PROBLEM ADVISORY

1. TITLE UT700 LEON3 FT SPARC V8 Microprocessor, 1553 peripheral transmission glitches on power-up sequence			2. DOCUMENT NUMBER SPO-2021-PA-0003									
			3. DATE (Year, Month, Date) 2021, February 1st									
4. MANUFACTURER NAME AND ADDRESS CAES 4350 CENTENNIAL BOULEVARD COLORADO SPRINGS, COLORADO 80907-3486			5. MANUFACTURER POINT OF CONTACT NAME info-hirel@cobhamaes.com									
			6. MANUFACTURER POINT OF CONTACT TELEPHONE (719) 594-8000									
			7. MANUFACTURER POINT OF CONTACT EMAIL info-hirel@cobhamaes.com									
8. CAGE CODE 65342	9. LDC START All	10. LDC END All	11. PRODUCT IDENTIFICATION CODE See table below	12. BASE PART See table below								
13. BLANK			14. SMD NUMBER See table below	15. DEVICE TYPE DESIGNATOR 01								
			16. RHA LEVELS R	17. QML LEVEL See table below								
			18. NON QML LEVEL N/A	19. GIDEP NUMBER GB4-P-21-03								
20. PROBLEM DESCRIPTION / DISCUSSION / EFFECT This document describes a corner case that affects all versions of the UT700 LEON 3FT SPARC V8 Microprocessor. (see appended).												
<table border="1"> <thead> <tr> <th>Base part number</th> <th>PIC</th> <th>SMD number</th> <th>QML Level</th> </tr> </thea

Figure 1: The figure shows the core voltage (blue color) during the powering up sequence and a glitch on the 1553 transmission signal (cyan color).

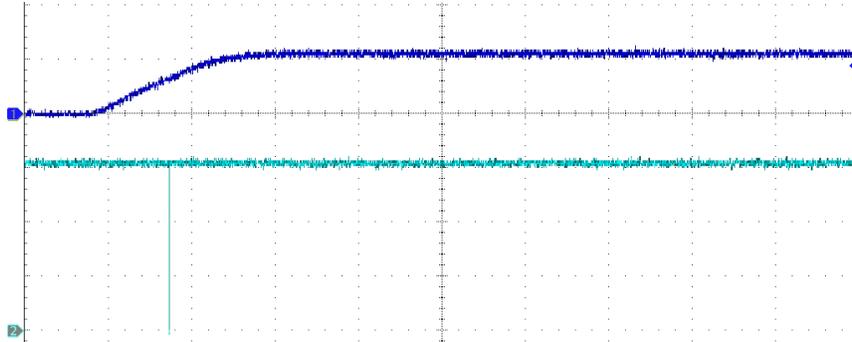
When the LEON processor is powering up with a minimum core voltage setting, its embedded 1553 module transmission signals might glitch (see Figure 1).

This anomaly will not affect the functionality of the 1553 module, but the transmission signal glitches might interrupt an active 1553 network operation.
